BOOMERANG

WIRING DIAGRAM CORRECTION

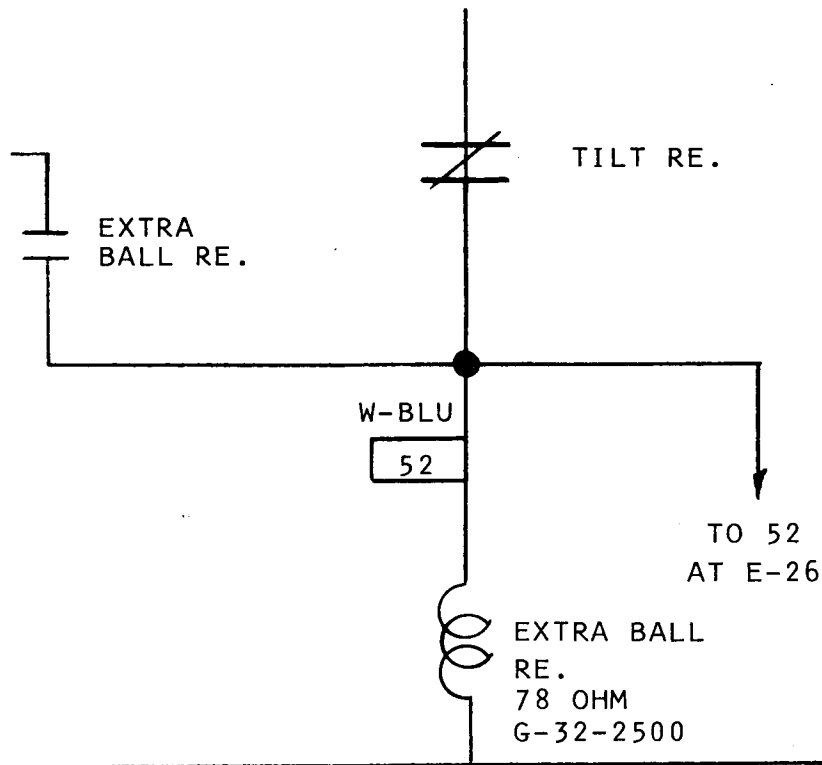
CORRECTION:
THE EXTRA BALL RE.
SHOULD READ AS
SHOWN.

LOCATION F - 9

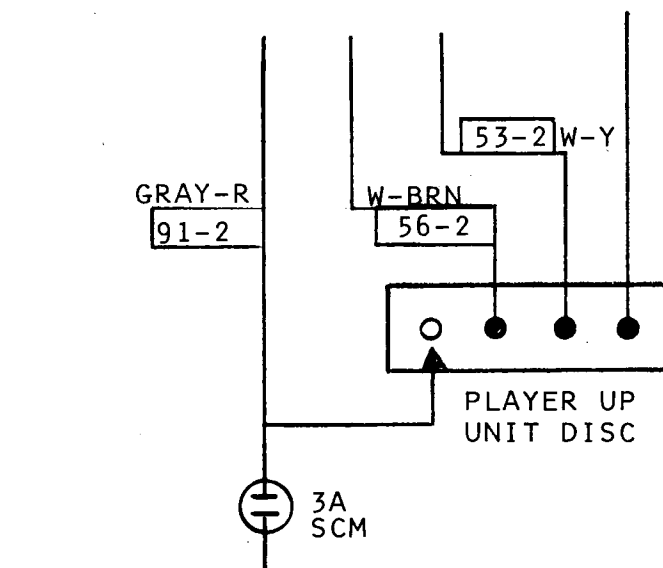
CORRECTION:
THE PLAYER UP UNIT
DISC IS NOT IDENTI-
FIED AS SUCH.
